PHAN, HAU VAN

**Office Action Summary**

10/604,304

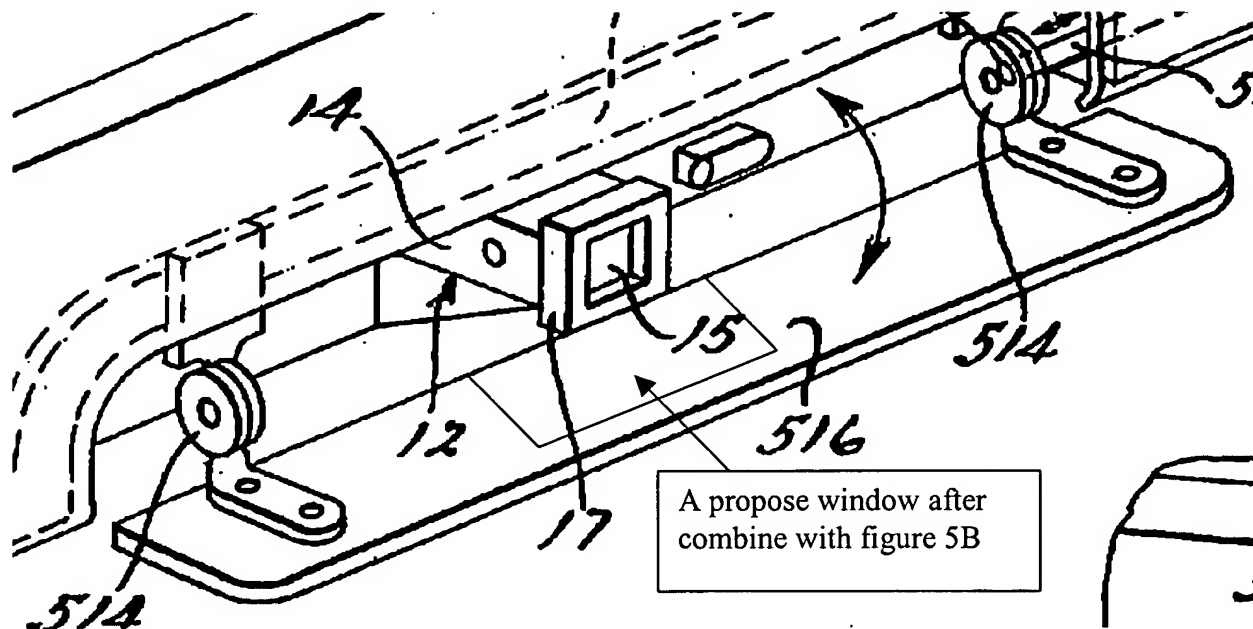
6. Applicant's arguments filed 5/31/2006 have been fully considered but they are not persuasive. In response to applicant's remark on page 2 that Blake teaches absolutely nothing about a rotatable window through which a hitch may be inserted. The examiner disagrees, because Blake in figure 8 discloses a step or a cover plate (516), but the cover plate does not have an aperture or a window. Blake in figures 5B or figure 6, teaches a trailer hitch cover assembly (110) including a trim fascia (170). The trim fascia has an aperture or a window (180). The trailer hitch cover assembly includes a cover assembly (286, figure 6, 186, figure 5B). The cover assembly includes a rotatable door or a cover plate (156, col. 7, lines 1-42) to cover the aperture or the window for the hitch can be inserted (see below drawing with a proposed window after combine with figure 5B).
